HITCH RACK RANCH QUARRY

M-2017-049

Subject: Responses to Preliminary Review of 112 Permit Application for Transit Mix Concrete Company, Hitch Rack Ranch Quarry, M-2017-049

RESPONSES TO FILING DEFICIENCIES ON HITCH RACK RANCH QUARRY PERMIT APPLICATION M-2017-049

Hitch Rack Ranch
Figure 4
Vegetation Communities
and Topography

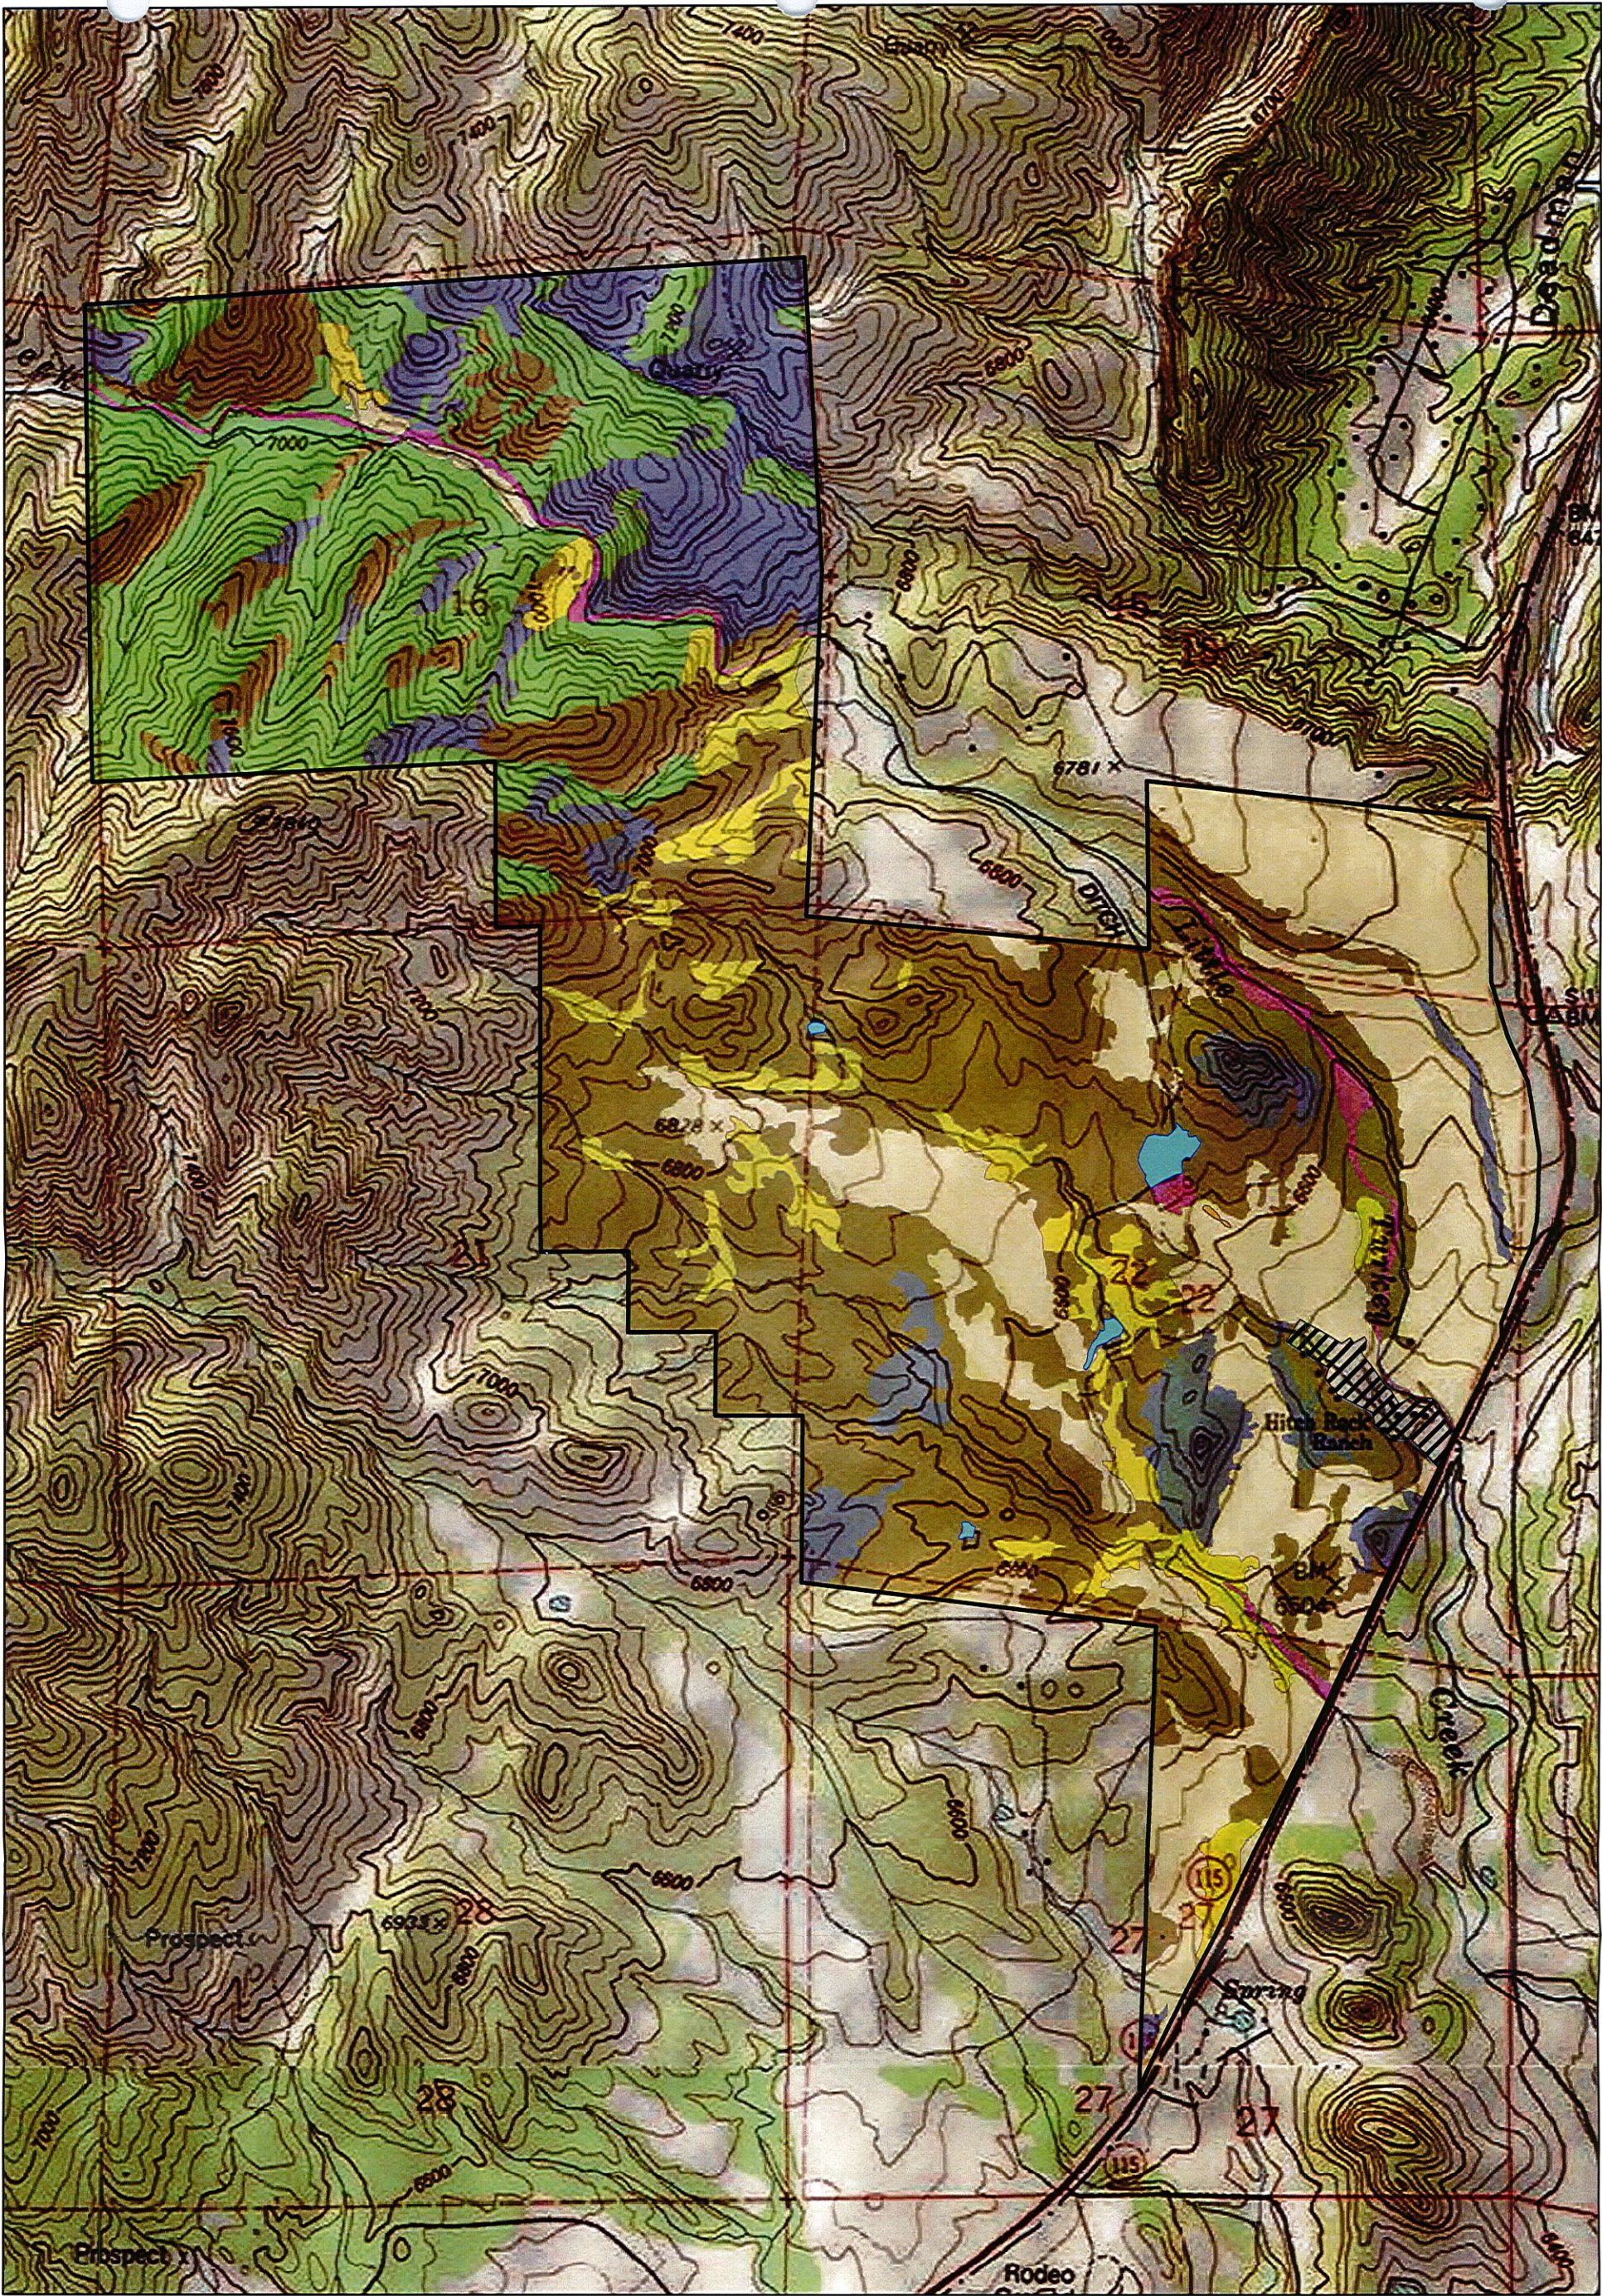
- 10) **Comment:** Pursuant to Rule 6.4.3(e), please provide a map which portrays the type of present vegetation covering the affected lands. The application referred to Exhibit J, Figure 4 for the vegetation information. However, the application did not include a Figure 4 with Exhibit J.

Response: The Exhibit J figures have been included with this submittal.

Figure L-1
Hitch Rack Ranch Quarry
Plant Site Structure
Demolition

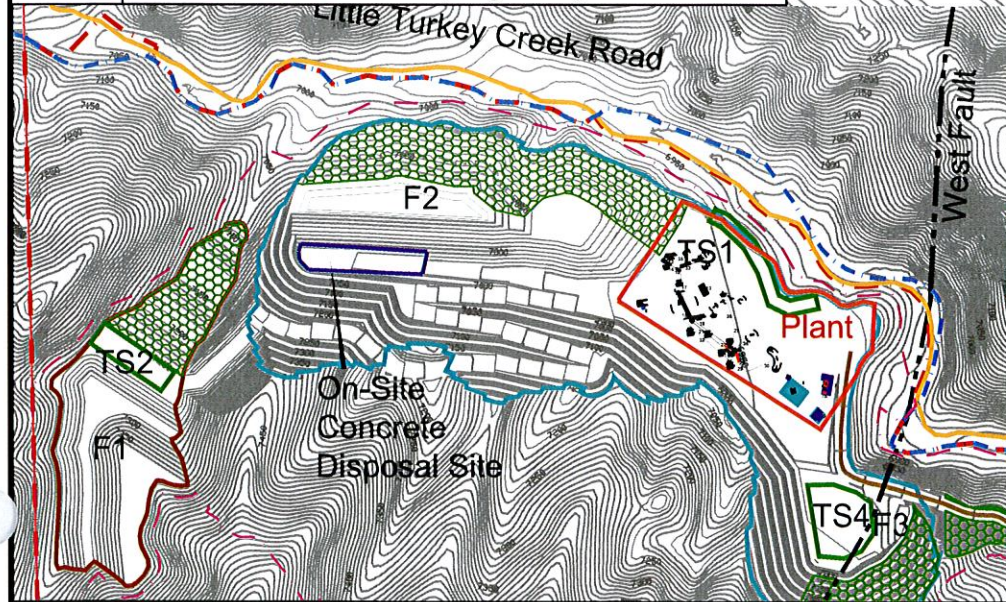
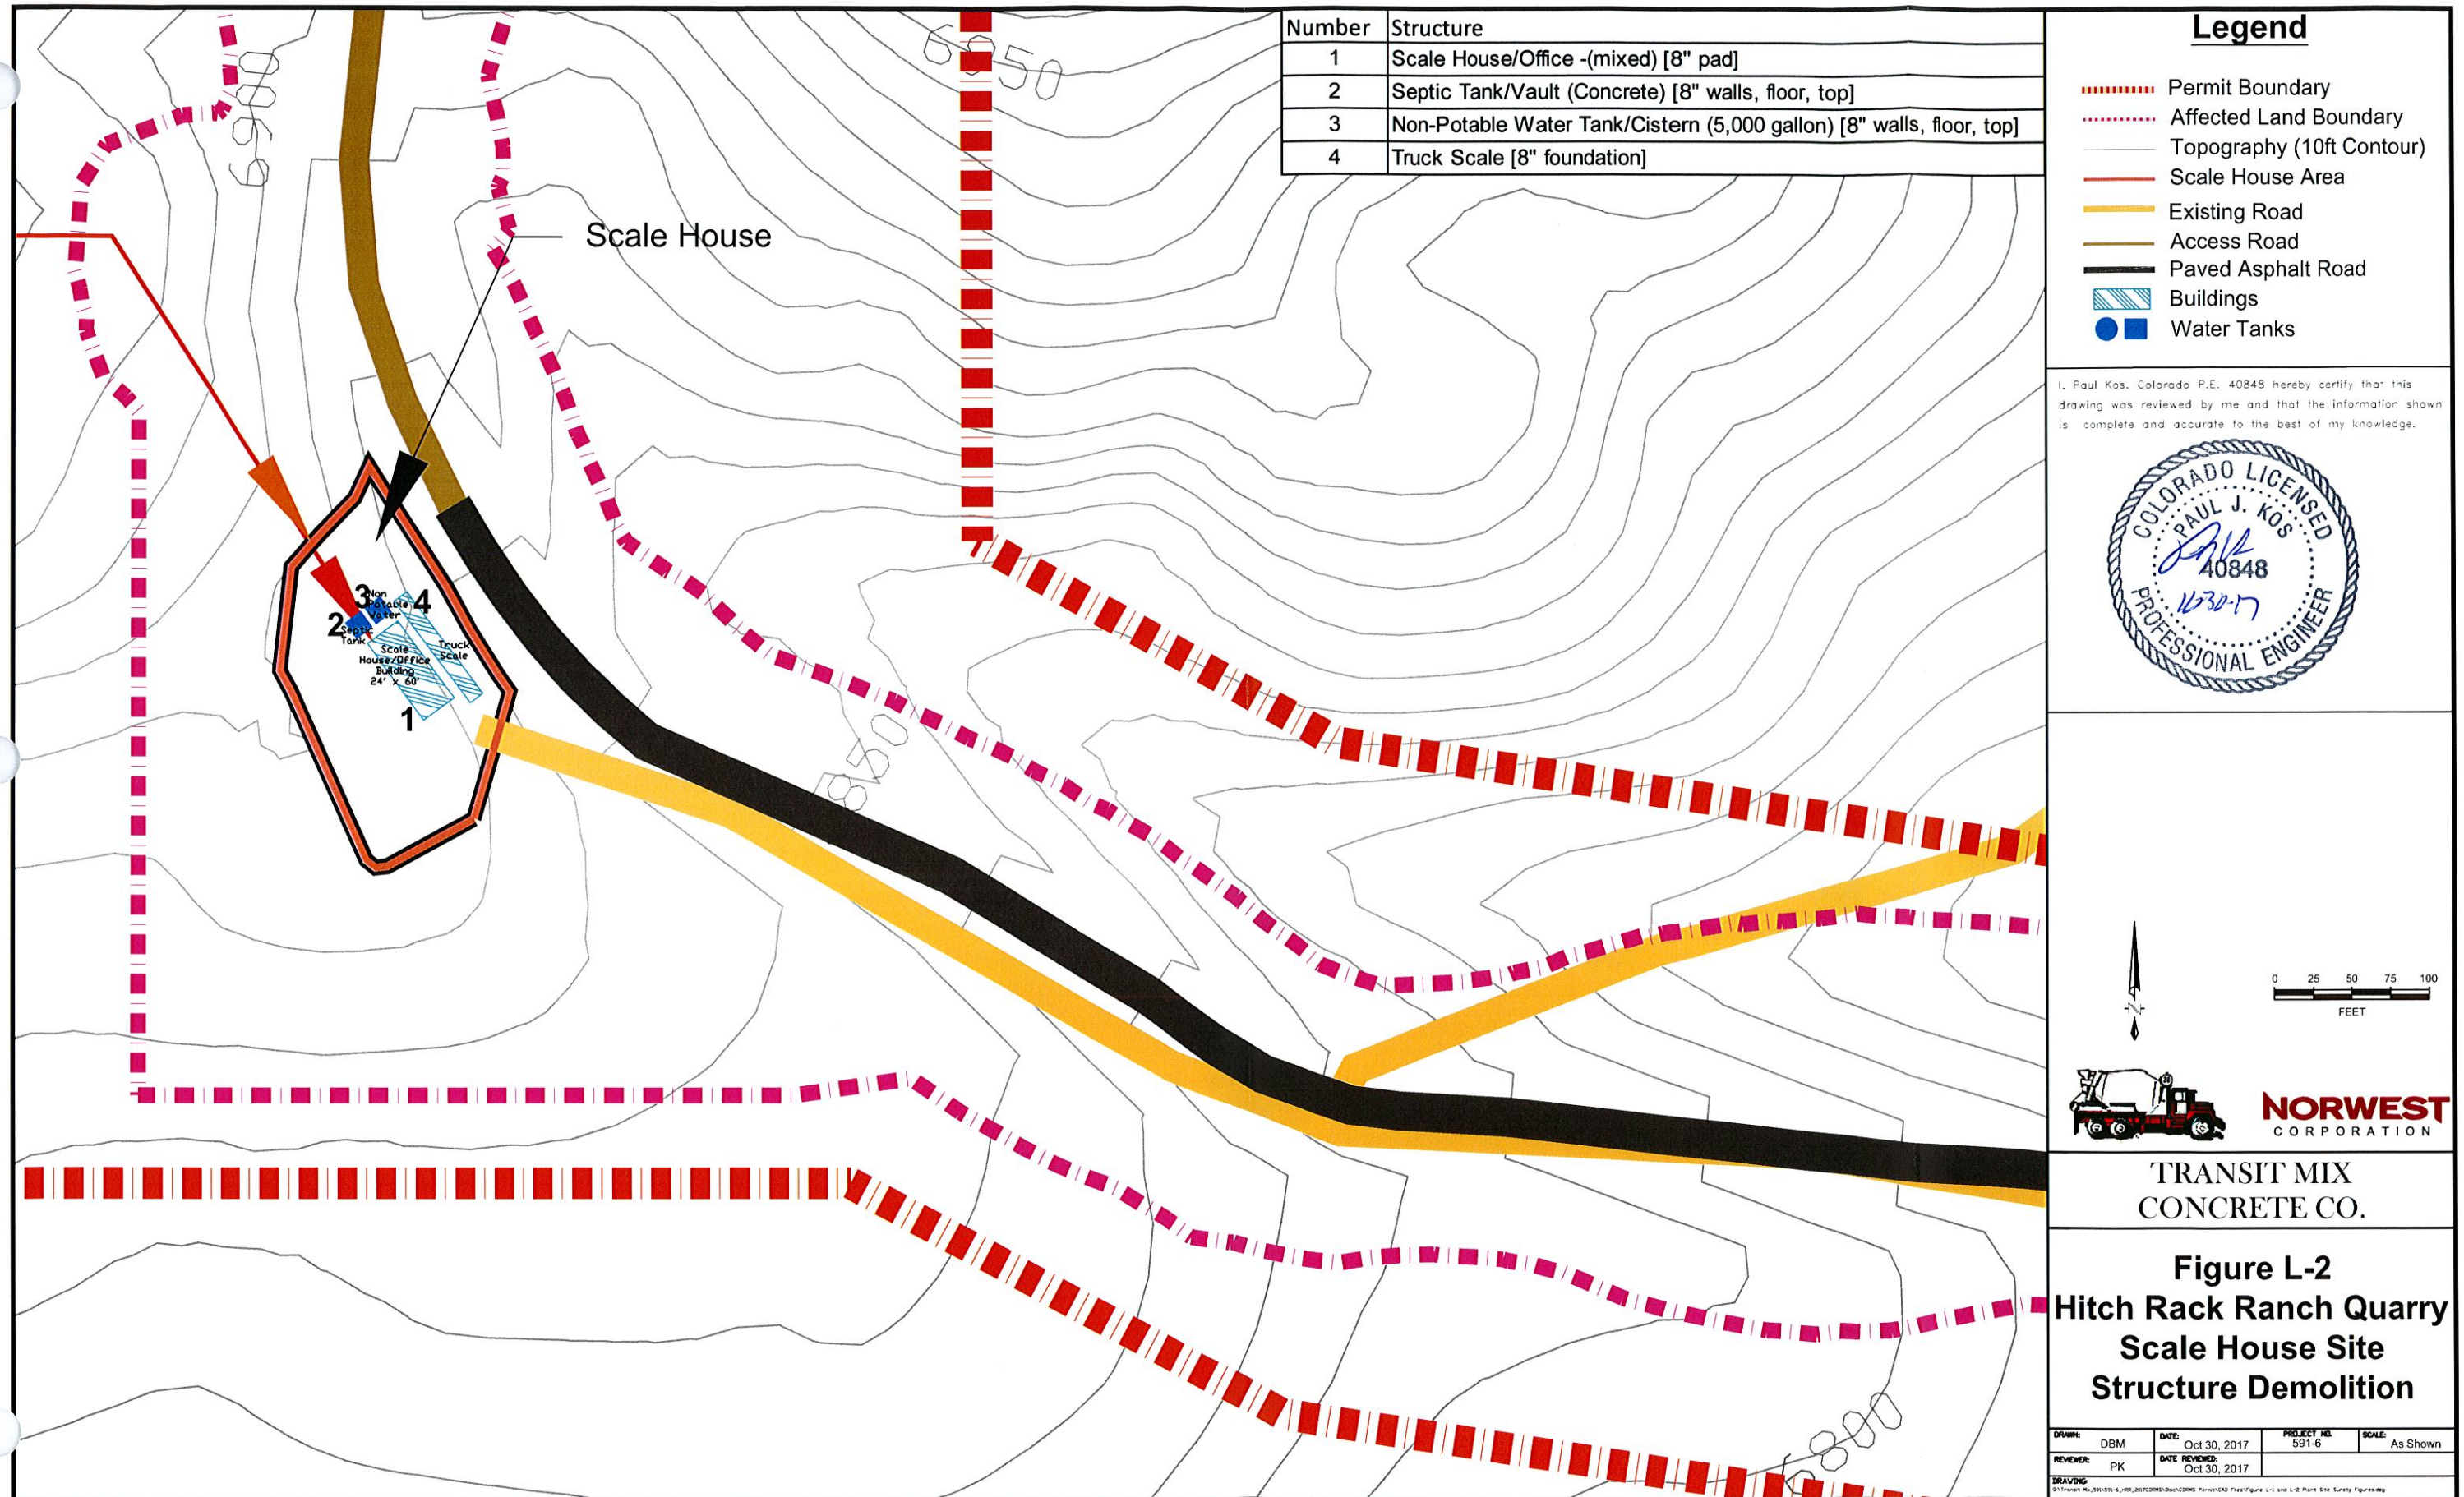
- 17) **Comment:** The Figure L-1 and Figure L-2 submitted with the digital copies are not identical to the Figure L-1 and Figure L-2 submitted with the original and all hard

copies. The digital copies have different images, text, and legends. They also have a different date (Sept. 5, 2017) than the date provided on the hard copies (Oct. 3, 2017). Please send replacement copies for the correct version of these figures. If the hard copy versions are correct, then please send replacement digital copies.

Response: The October 3, 2017 version of these maps is correct. New copies and a digital copy of the maps dated October 30, 2017 is included with the submittal.
